OLIVER RANCH
PUD / POADP PLAN

Re: Oliver Ranch (Amending)

MDP/POADP # 662-C

The City Staff Development Review Committee has reviewed Oliver Ranch (Amending) Master Development Plan M.D.P. (formerly POADP) Preliminary Overall Area Development Plan # 662-C. Please find enclosed a signed copy for your files. Your plan was accepted however please note the following:

TRACT VIA PH II TYPICAL LOT DETAIL
NOT-TO-SCALE

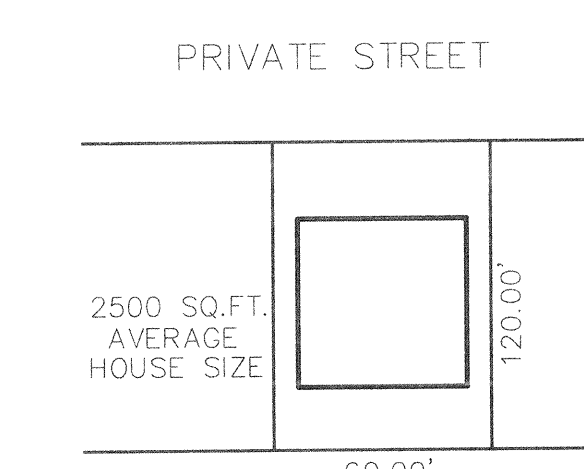
- TRACT VIA PHASE II
RESIDENTIAL LOTS WERE CHANGED FROM 70' LOTS
TO 60' LOTS— (STREET LAYOUT REMAINED
UNCHANGED)
- REVISED DENSITY TABLE.
- REVISED 100 YEAR FLOOD PLAIN TO REFLECT
CURRENT FLOOD PLAIN DELINEATION PER FEMA
LOMR CASE NO. 03-06-678P APPROVAL
PENDING.
- ADDED TYPICAL LOT DETAIL FOR TRACT VIA,
PHASE II

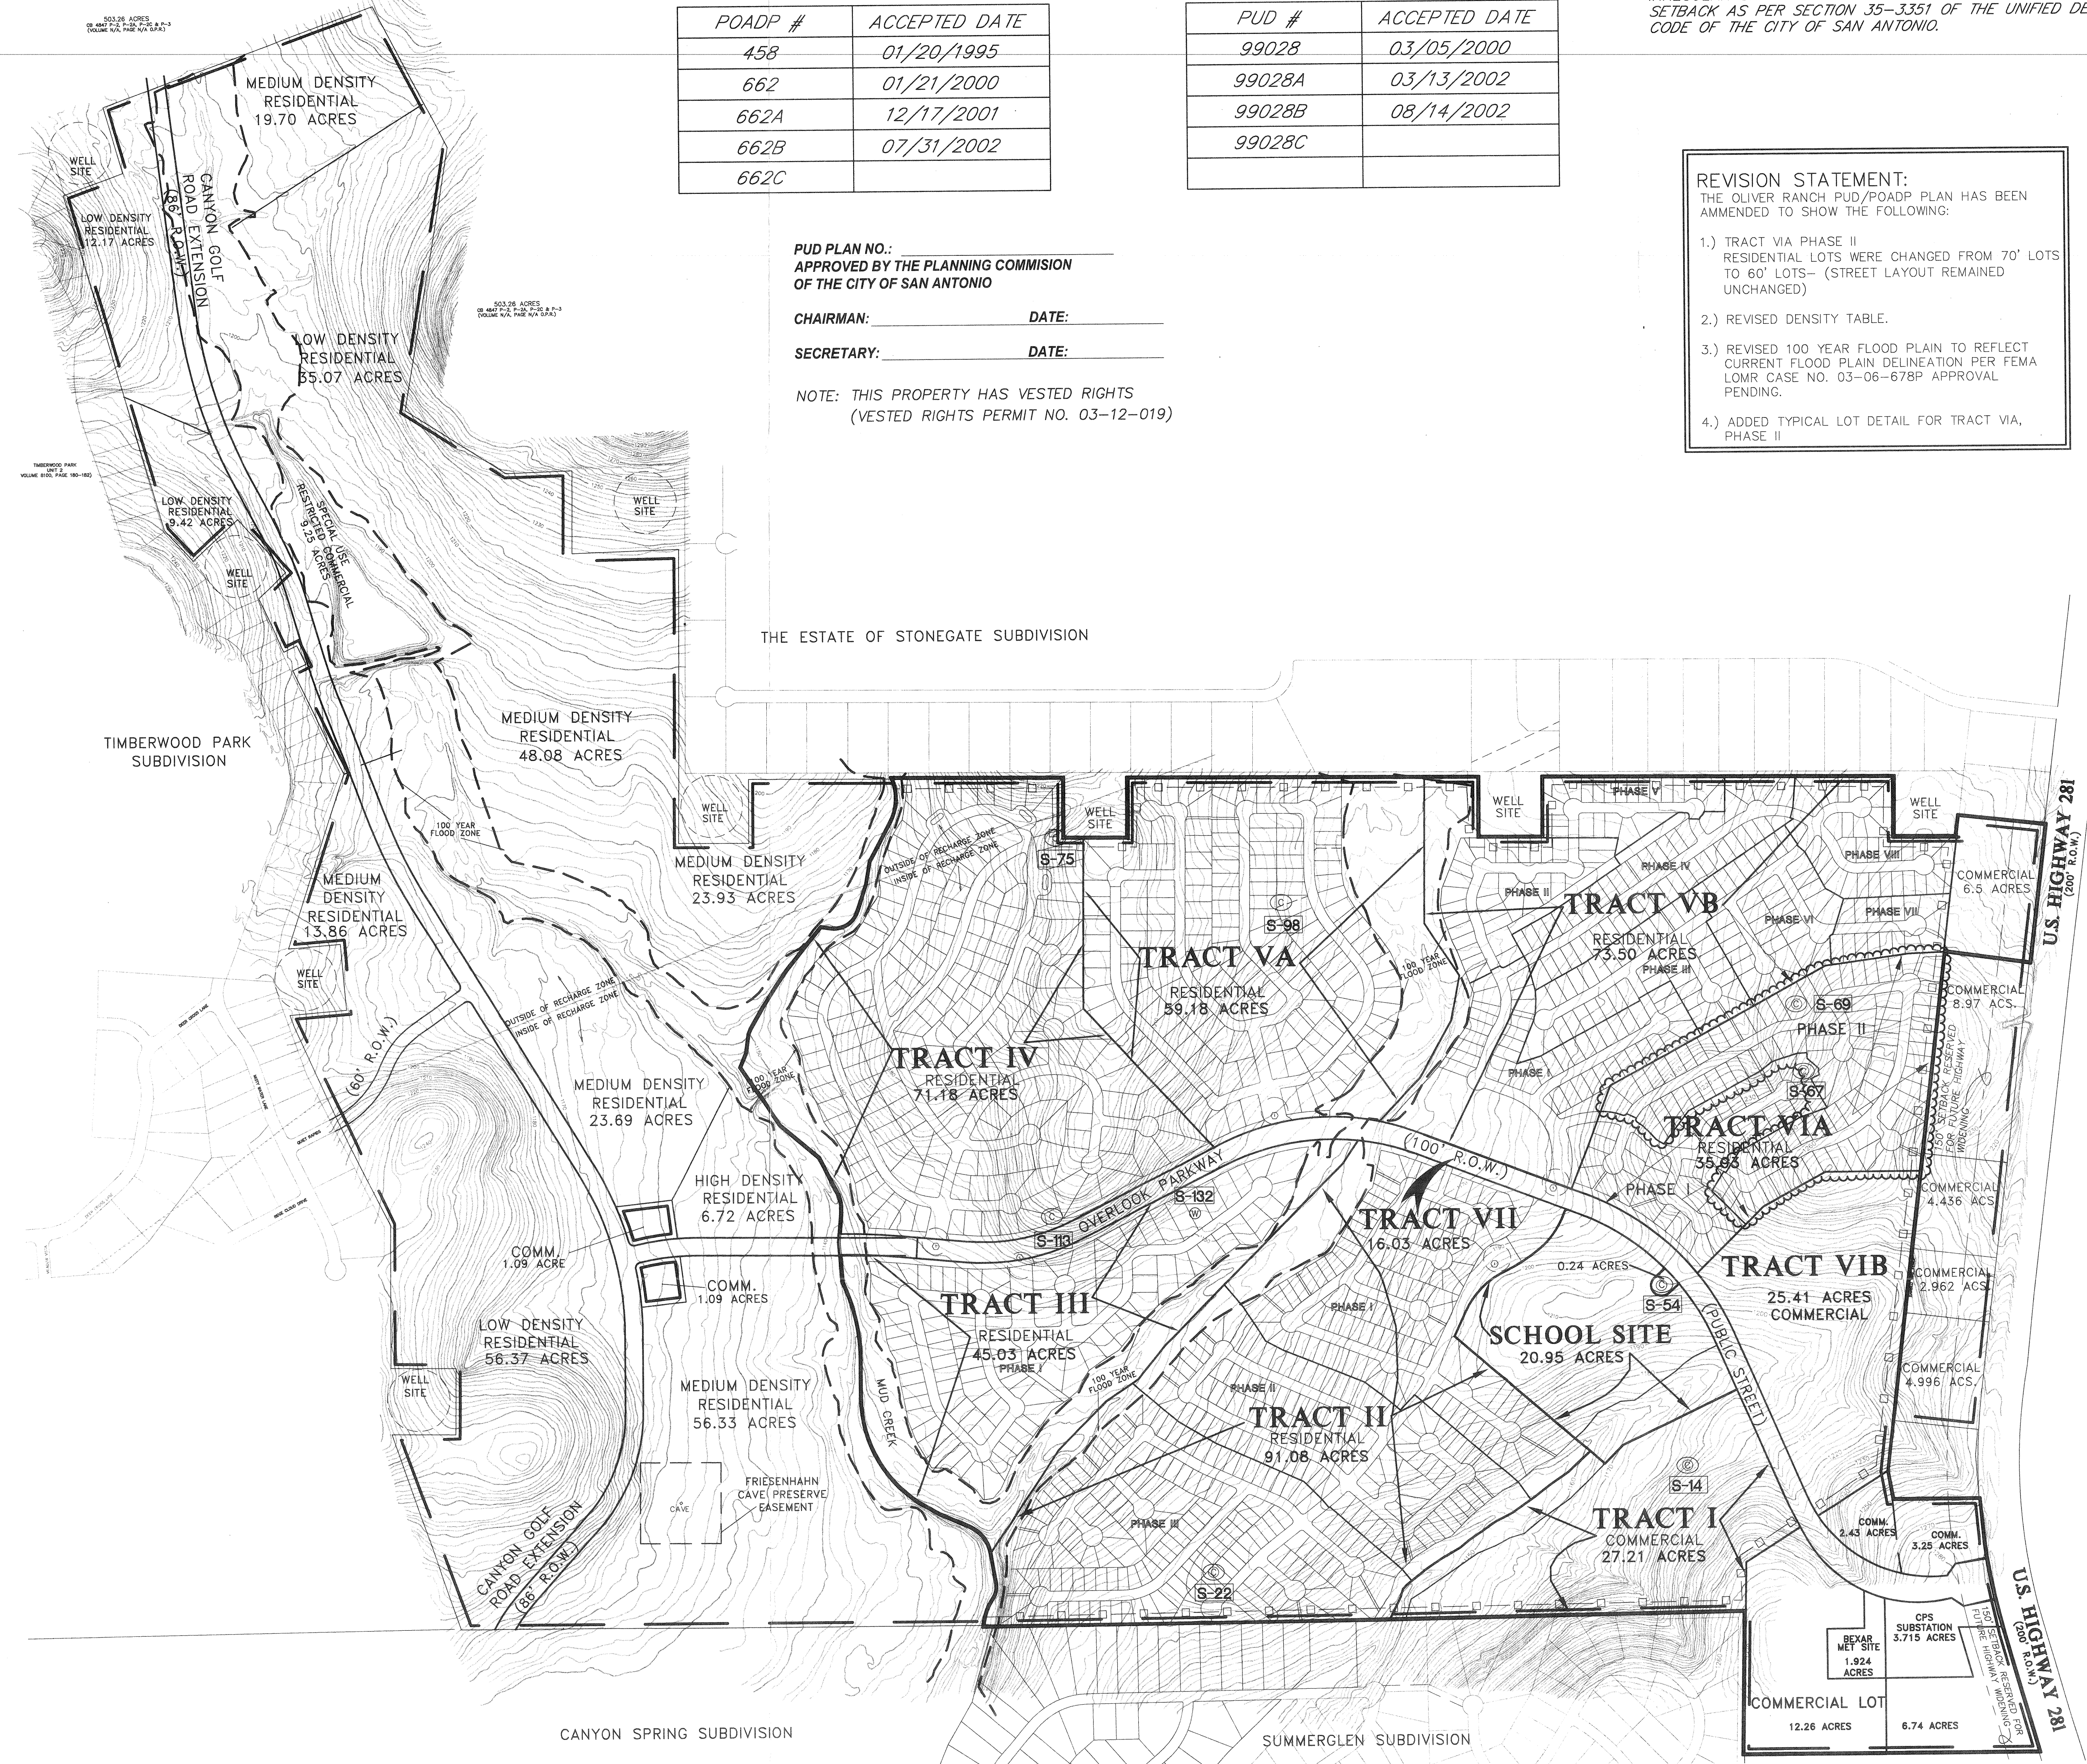
Please verify that the ultimate condition impervious cover is consistent with the City of San Antonio. Show the current revised 100-year flood plain to reflect ultimate conditions for LOMR case no. 03-06-678P on the MDP (the MDP show the Zone A delineation).

Response: MDP has been revised to reflect the detailed mapping
